UELAND TREE FARM MINERAL RESOURCE DEVELOPMENT

Proposed CUP Modifications
Final Supplemental EIS

Prepared for:
Kitsap County

August 2015

Figure 3-1
Ueland Tree Farm
Site Map

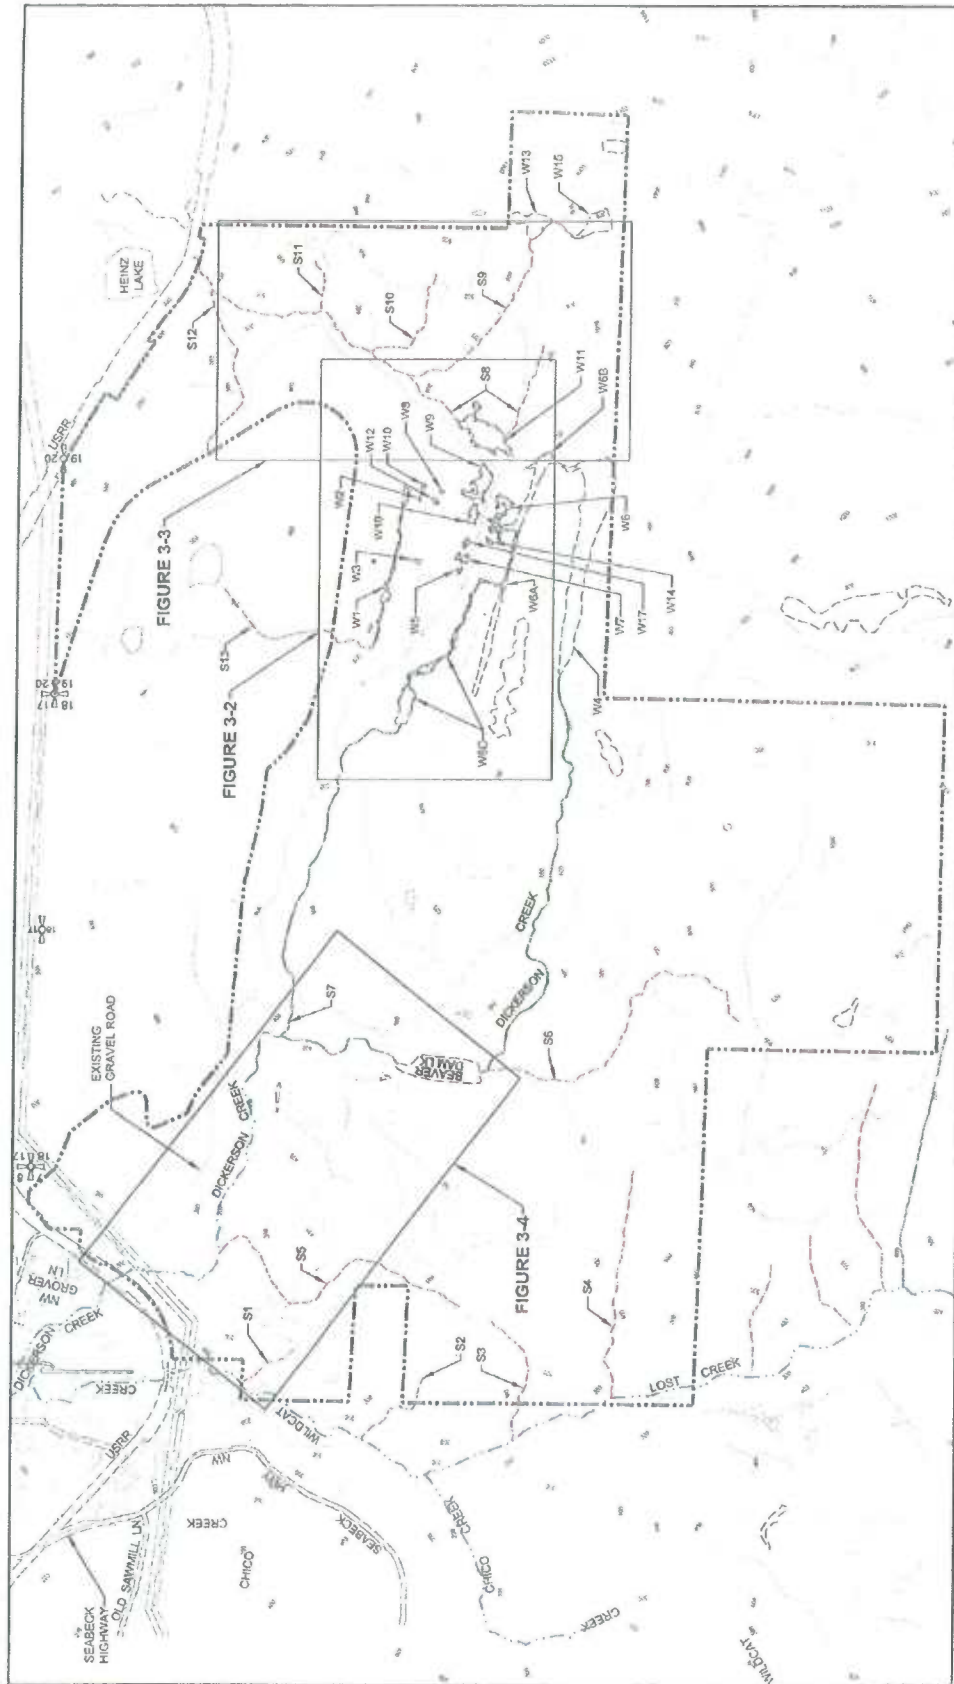
- Again, I have not been to this wetland and would have to perform a site assessment to be able to definitively concur.
- 6 5. The proposed quarries are shown at two different distances from the correct Wetland 4 (in the Beaver Pond of Dickerson Creek) in the project documents (Mineral Resource Development and Preliminary Reclamation Plan (Application package to Kitsap County, 2009) and Wetland Delineation Report (Parametrix, 2009, C11). On Figure 2-1, the distance is 120 feet from the north edge of the proposed quarry and in the application submittal the distance is identified as 200 feet. This discrepancy needs to be resolved and documented in the application submittal and the appropriate impact assessment must address any impacts within the correct buffer distance. Proposed mitigation needs to be developed that addresses the correct impact and added to the application package.

Figure 2. Wetland 4 - Solving the Confusion -Maps (Leyda 2012)

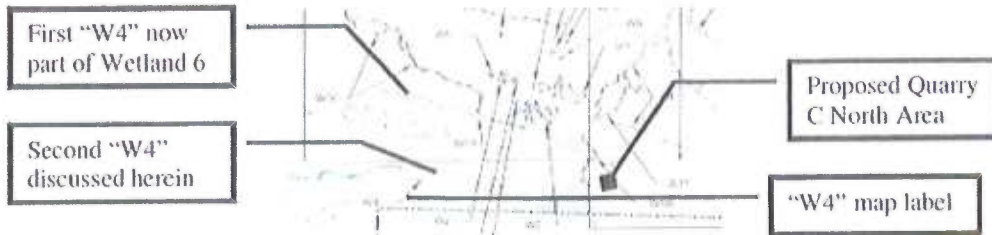
1. Wetland 4, which one? There seems to be some confusion about which Wetland 4 is being assessed and identified in both the reports and during the Kitsap County hearing (2010), the Hearing Examiner's denial of the SEPA Appeal, and the Superior Court dismissal of the Appeal. This wetland is the closest to the proposed mine and so just ignoring this confusion is not an option with respect to understanding potential impacts as a result of the proposed mining project. Leyda in his (6/4/12) report lays out the confusion about Wetland 4 (Figure 2). Initially, Parametrix identified a Wetland 4 that was separate but located at the north end of Wetland 6. Molly Adolfson (ESA, June 2015) stated this was part of Wetland 6 mentioned in the EIS but this is inaccurate there are actually 2 wetland 4's identified in the materials so there is some confusion that persisted in the hearing (Leyda 6/4/12). It is important that the permit application and record accurately reflect the two wetland 4's and resolve the confusion with respect to Wetland Ratings, and buffer assignments.

Leyda Report (6/4/12). First mention of Wetland 4 shows it as a separate wetland but at the north end of Wetland 6.

Leyda Report (6/4/12). The Wetland Delineation Report, Figure 3-2 (Parametrix, date) shows original Wetland 4 now incorporated into Wetland 6.

Leyda Report (6/4/12). Same Wetland Delineation Report, Figure 3-1 (Parametrix, date) shows Wetland 6 and a second Wetland 4 (located at the beaver pond in Dickerson Creek) now incorporated into Wetland 6.

Figure 3. Soil Erosion Ratings

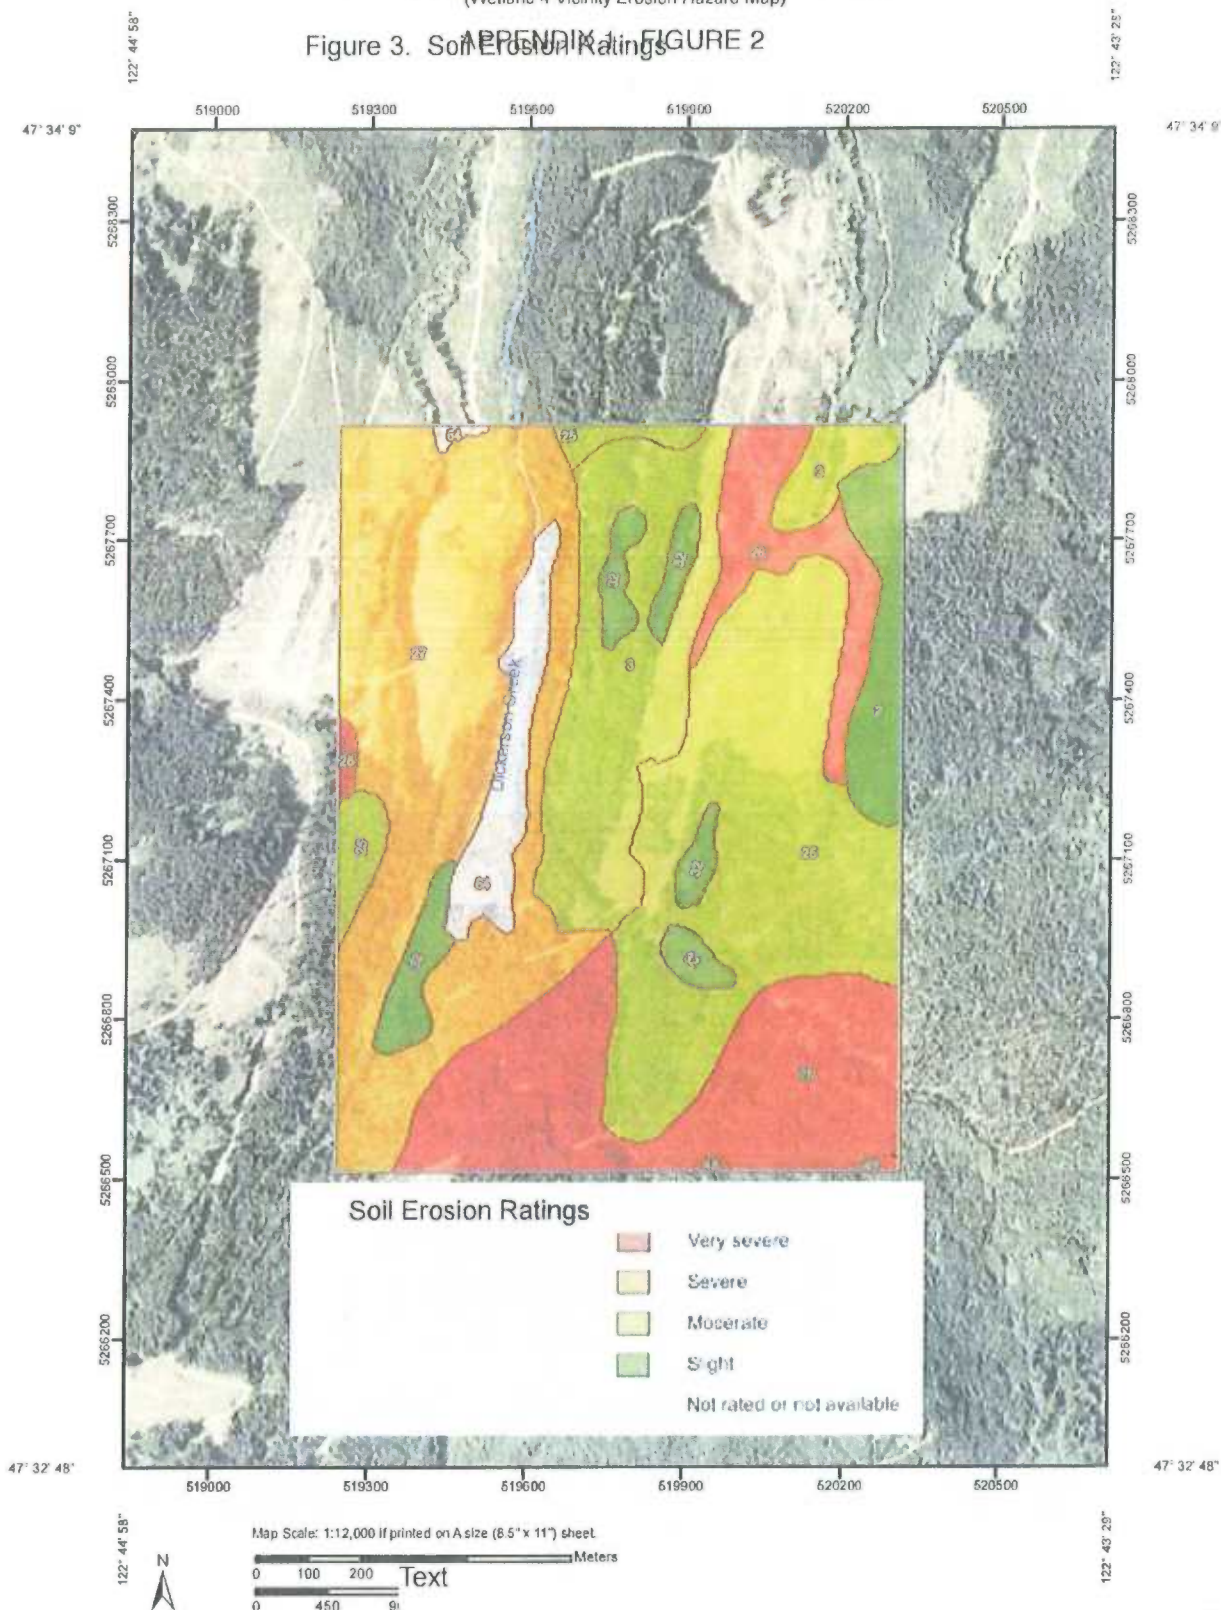
Severe" erosion hazard when disturbed (Figure 2, attached). These soils are very likely to erode and be trapped by Wetland 4. The cleared area to the west is visible on the Erosion Hazard Map, and the

Figure 5. Proposed Haul Road Wetlands and Road Alignment

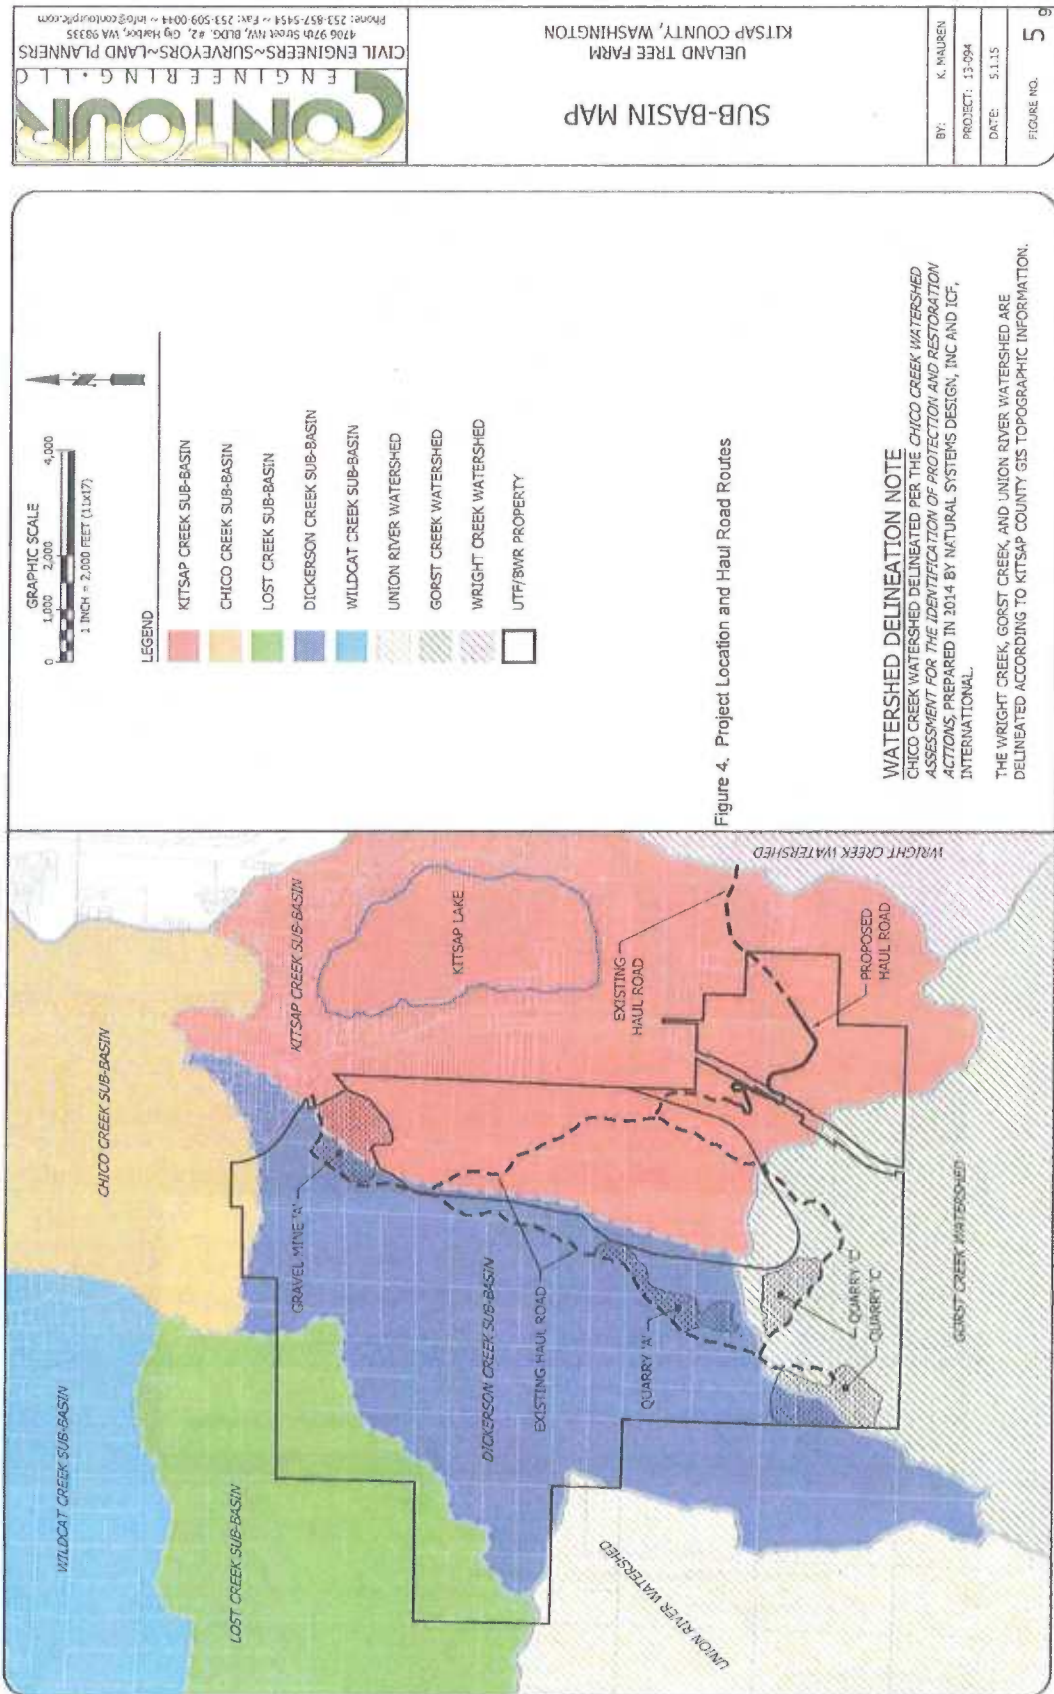
- 15 • 135 –acres is a large area to cover with a wetlands and stream reconnaissance and it would not be
unusual to omit small wetlands, especially give this type of landscape dominated by shallow soil
layer and shallow groundwater over bedrock. It will be important for the County and US Army Corps
of Engineers to verify the wetlands that are within the buffer of the project impact zone. Figure 5
identifies the proposed haul road and the wetlands and environs that would be nearby.

Wetland 4 as part of the Wetland 6 complex and the Dickerson Creek Wetland 4

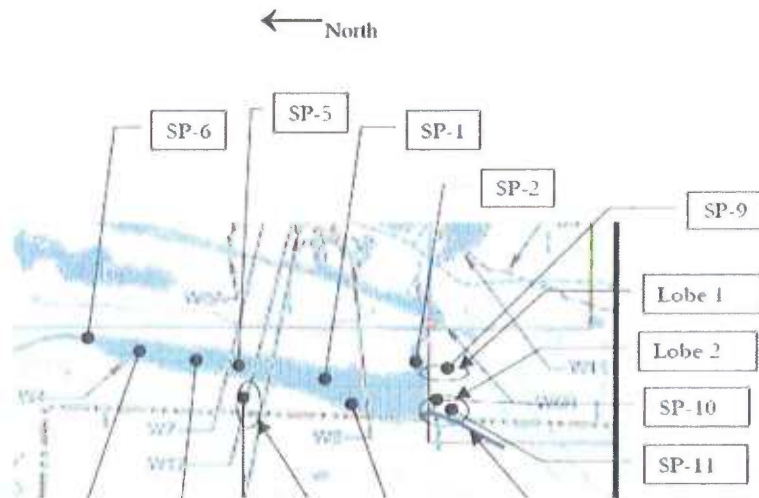
The Wetland 4 boundary observed by LCI in the field was different from the boundary as shown by Parametrix and in the Mineral Resource Development and Preliminary Reclamation Plan. Notably, two lobes were found on the south end (Lobe 1 and Lobe 2) that project toward the proposed Quarry C, and one additional lobe (Lobe 3) was found on the western edge. Lobe 2 on the south end has Dickerson Creek running through it, with a defined channel and ordinary high water mark (Photo 24). LCI did not follow the channel to the source, but observed it within the boundary of Wetland 4. Lobe 1 is forested with tree, partial shrub, and herb layers, and mostly inundated soils (see Sample Plot 9). Lobe 1 is the smaller of the two, and is approximately 75-feet wide at the beaver pond end, and approximately 75-feet long (approximately 5,625 square feet or less). Lobe 2 is forested, with tree, shrub, and herb layers, and two western redcedar (*Thuja plicata*) trees were observed near Sample Plot 10 that had diameters greater than 24", and one of those approximately 36" in diameter. The soils in Lobe 2 are mostly saturated at or below the soil surface, with puddles in places. Lobe 2 is approximately 275' wide at the junction with the beaver pond, and approximately 200' long (approximately 55,000 square feet, or 1.26 A, or less).

Inset 5. Clipped from Habitat Management Plan, Fig. 4-1 (north is to the left). Two tributaries joining offsite from the southwest add considerable flow to Wetland 4.

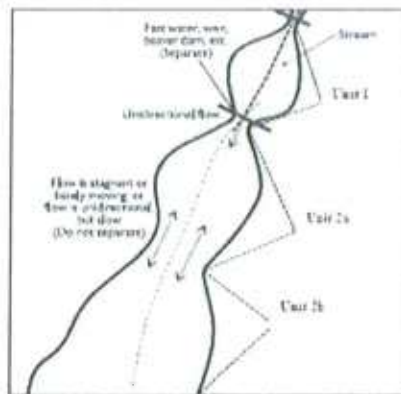
Because of the position of Wetland 4 along the creek, the rating rules for "Wetlands in a Series of 13

Inset 6b. Graphic from manual, marked with features from Wetland 4 to illustrate the similarity of Wetland 4 to the graphic. The blue arrow callouts symbolize the water inputs to Wetland 4.

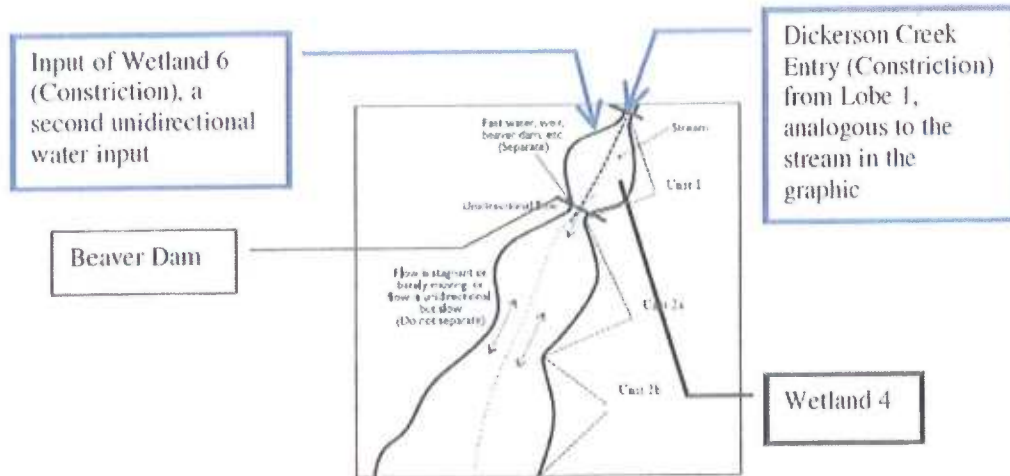
Wetland 4 was created by a beaver dam in a stream, like the theoretical wetland in the graphic. Wetland 4's configuration matches this theoretical configuration shown in Inset 6a. They both have a beaver dam, a stream in the middle, and a natural constriction at the top where the stream enters (edge of Lobe 2).

In addition to the creek entering through a constriction, Wetland 6 also enters through a constriction as it drains into Wetland 4. Inset 6b shows the theoretical example from the manual marked with the actual site features in diagrammatic form. Imagine the theoretical example with two constrictions on top, one from the creek, and one from Wetland 6. This is the case with Wetland 4.

Inset 8. Approximate location of Lobe 1, and the proposed stormwater discharge to the Wetland 4 buffer, which is very likely in or near the unmapped Lobe 1 of Wetland 4. (Clipped from *Mineral Resource Development Plan, Sheet C11*).

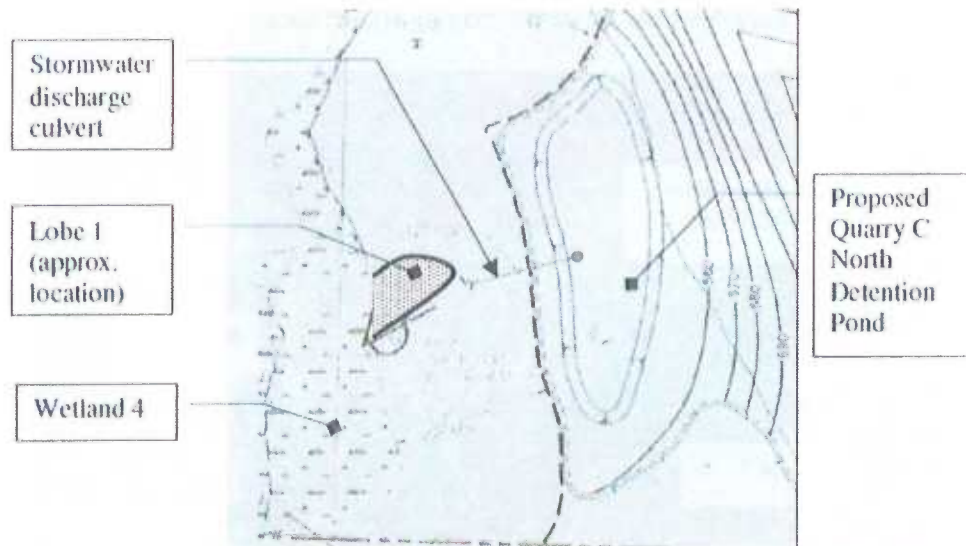
The opportunity to improve water quality will exist after the proposed quarry construction, since the proposed Quarry C North detention pond is shown to discharge to a topographic low point in the Wetland 4 buffer about 120' from the edge on the map (Mineral Resource Development Plan, Sheet C11). In reality, that topographic low point is either in or very close to the unmapped Lobe 1. Because 50% of the stormwater will be untreated (see F. Wetland 4 Hydrology and Proposed Quarry Stormwater Plan, and because the rating manual says even treated stormwater is polluted, Wetland 4 will have the opportunity to improve water quality after construction.

Although the Construction Notes on Sheets G2 says that deviations from the plan may be necessary (from the general Erosion & Sediment Control Notes, Note 6), which means the exact culvert discharge point could deviate from the plans, the topographic low point will not change, and the stormwater will flow to that topographic low point which could be lobe 1 of Wetland 4.
